Detailed Site Plan
Alternative Compliance
Giac Son Buddhist Temple

DSP-20002
AC-22009

STAFF REPORT

SUBJECT: Detailed Site Plan DSP-20002
Type 2 Tree Conservation Plan TCP2-018-2023
Alternative Compliance AC-22009
Giac Son Buddhist Temple

Figure 1: Architecture Elevations

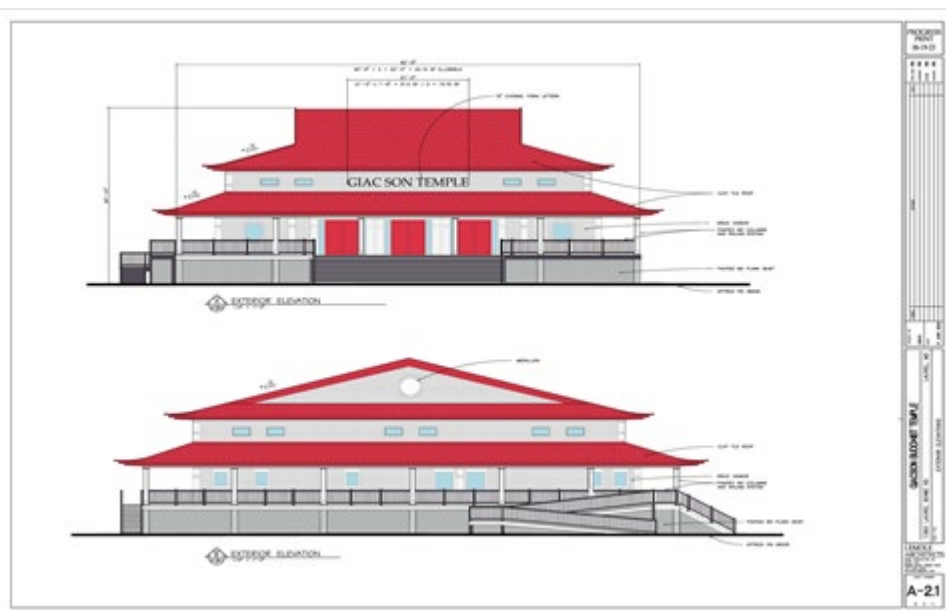
Prior to the first Planning Board hearing on June 22, 2023, staff determined the Buddha statue is an “accessory structure” and that the maximum allowable height for an accessory structure in the Rural Residential (R-R) Zone is 15 feet. This information was provided to the Planning Board by staff at the June 22, 2023 hearing, and the Planning Board heard testimony from the applicant on the issue. Staff’s determination was based on the following:

Staff find the proposed architecture to be sufficient, subject to conditions. These include revising the height of the proposed building labeled as Site Note 25 on the DSP coversheet to match the height provided on the architectural elevations; providing dimensions of the proposed building entrances; providing floor plans of the proposed place of worship; providing the material and colored elevations of the Buddha statue and courtyard; labeling the elevation facing Snowden Road as a side elevation on the architectural elevations and Site Note 26 on the DSP coversheet; and requiring the height of the Buddha statue to not exceed 15 feet, per Section 27-442(i) of the prior Zoning Ordinance.

- j. Revise the architectural elevations on Sheet 7 to clearly label the material of the proposed attached signage.
- k. Provide a colored rendering of the freestanding signage proposed on Sheet 10.

- l. Provide floor plans for the proposed Buddhist temple.
- m. Provide the dimensions of the building entrance doors on the architectural elevations on Sheets 7 and 8.

- x. Revise the Buddha statue height to not exceed the requirements associated with Section 27-442(i) of the prior Prince George's County Ordinance, for properties in the Rural Residential Zone.
